L-2000-028
10 CFR §50.90

Re: Turkey Point Units 3 and 4
Docket Nos. 50-250 and 50-251
Proposed License Amendments
"Revised Pressure/Temperature (P/T) Curves, and
Cold Overpressure Mitigation System (COMS) Setpoints"

ATTACHMENT 1

Description Of Proposed Amendments

FIGURE 3.4-2 Turkey Point Units 3 and 4 Reactor Coolant System Heatup Limitations (Heatup Rate of 60 and 100°F/hr) Applicable for 32 EFPY (Without Margins for Instrumentation Errors)

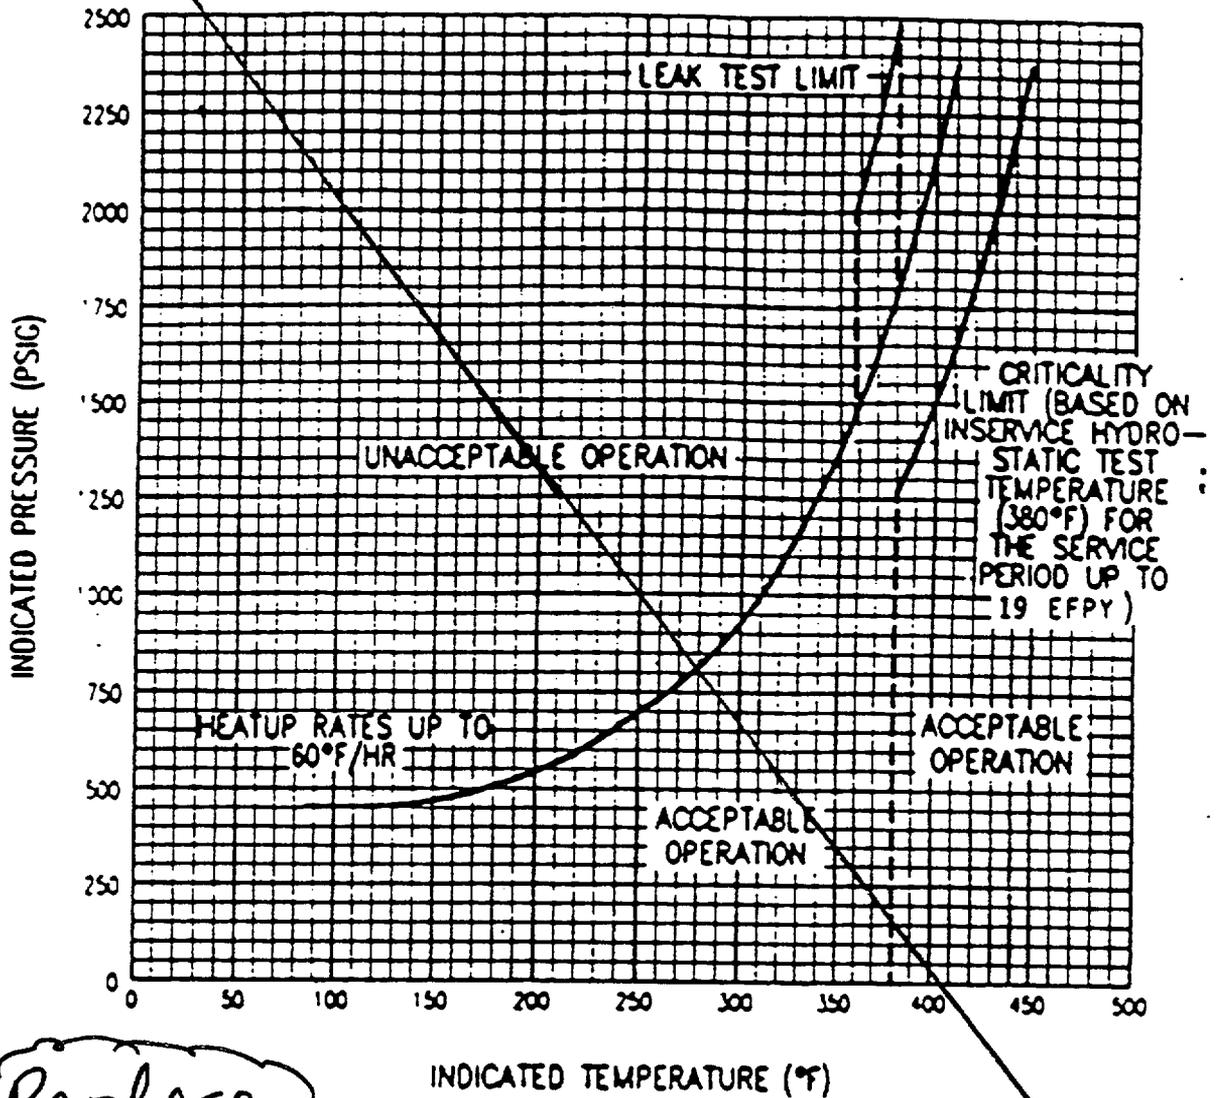
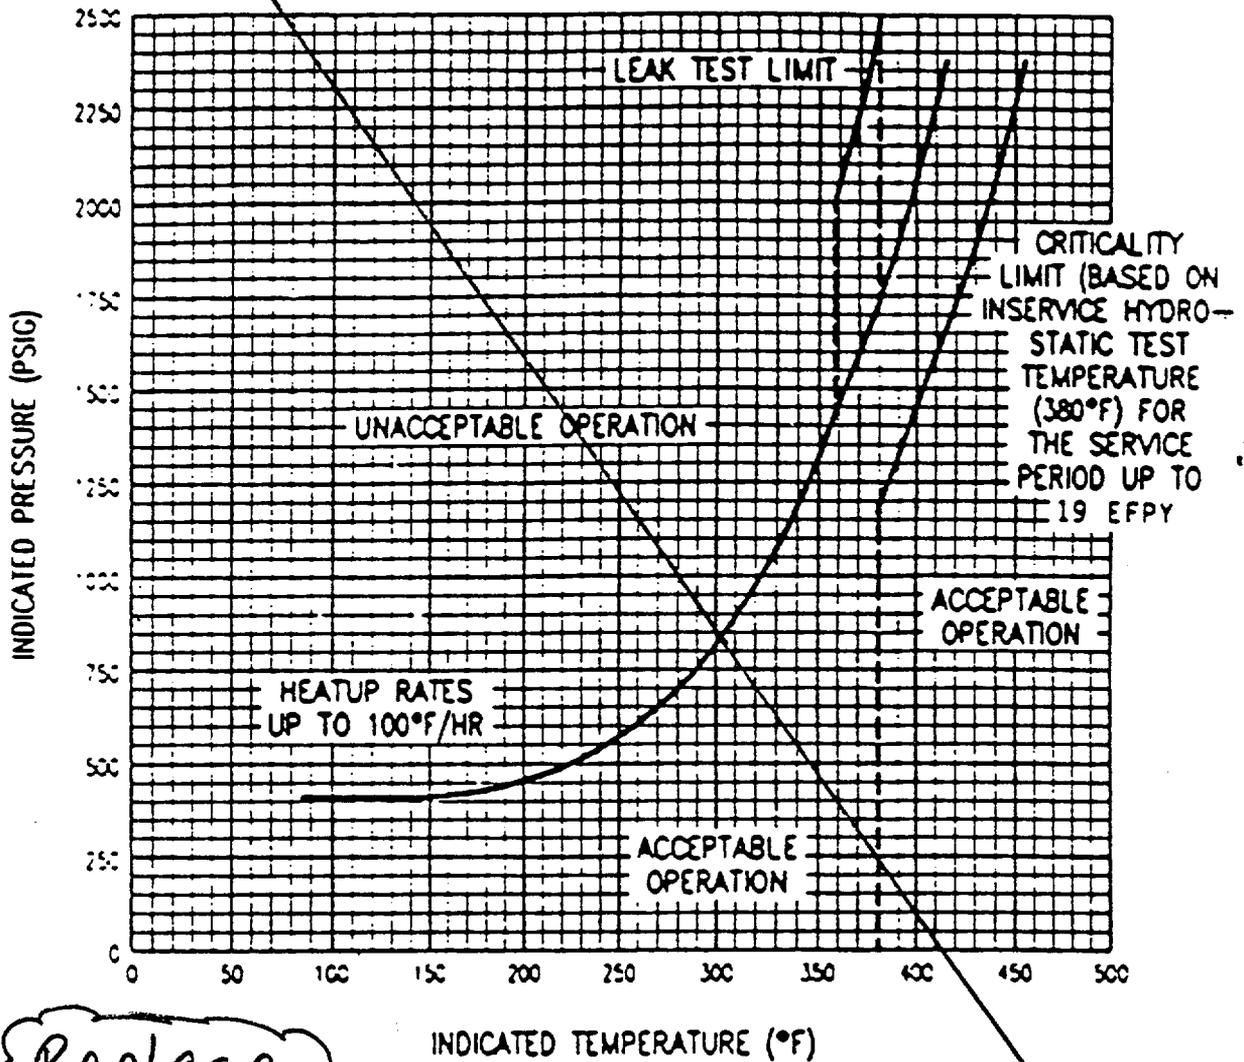
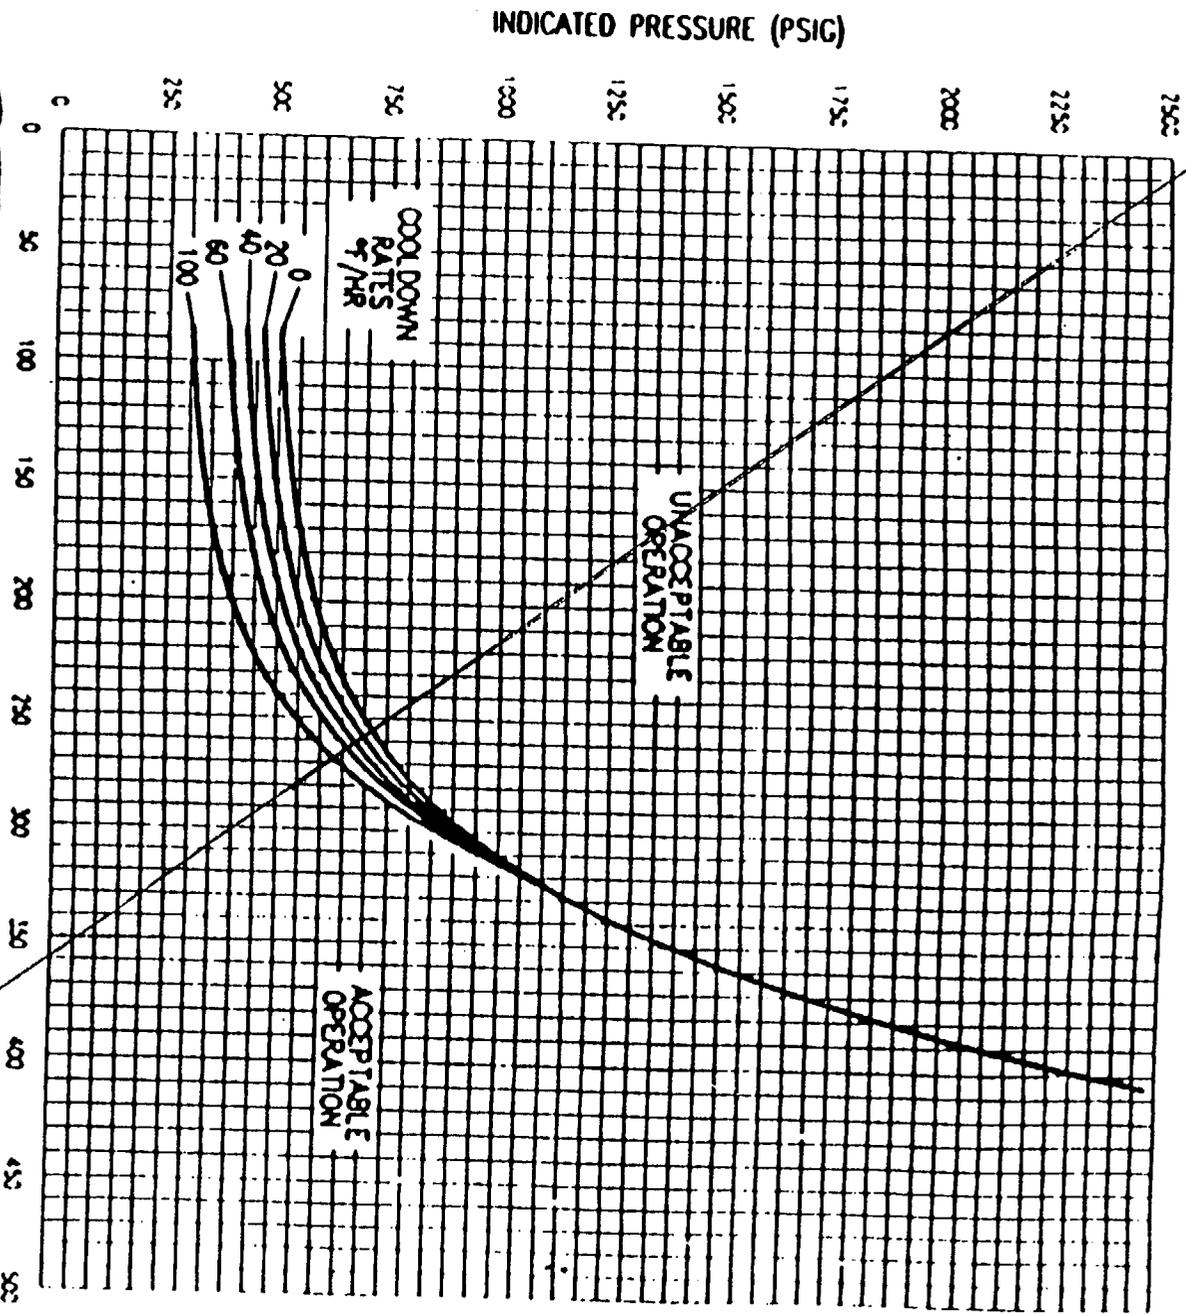
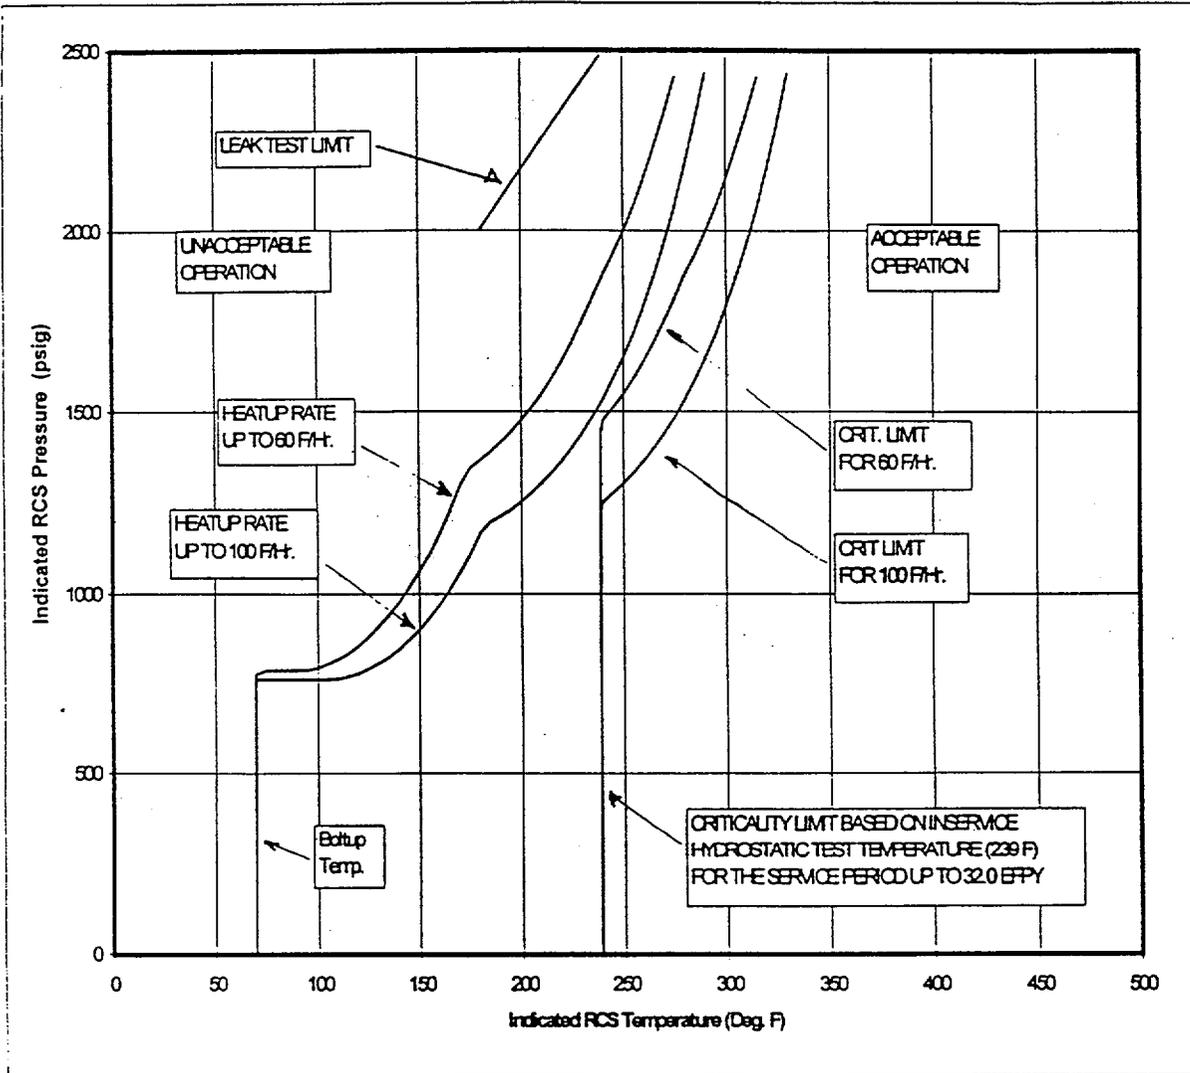
- e) **Technical Specification Figures 3.4-2, 3.4-3, and 3.4-4: Replace these three current figures with two new Figures 3.4-2, and 3.4-3, to reflect the Pressure/temperature Limits applicable for the service period up to 32 EFPY, as opposed to the present 19 EFPY.**

Discussion: The 32 EFPY curves replace the 19 EFPY curves. The new heatup curves have the 60 °F/hour and 100 °F/hour rates on one sheet. The 19 EFPY curves were separate for each heatup rate. The curves themselves have no instrument uncertainty built in but the associated COMS setpoint does have the uncertainty margin included. The new curves are complete to minimum bolt-up temperature whereas the 19-year curves stopped at 80 °F. The 32 EFPY curves have a compound slope which shows the effect of Code Case N-588. This slope reflects the fact that at low temperatures the forging with its assumed longitudinal reference flaw dominates because hoop stress dominates. The weld is limiting for most of the range.
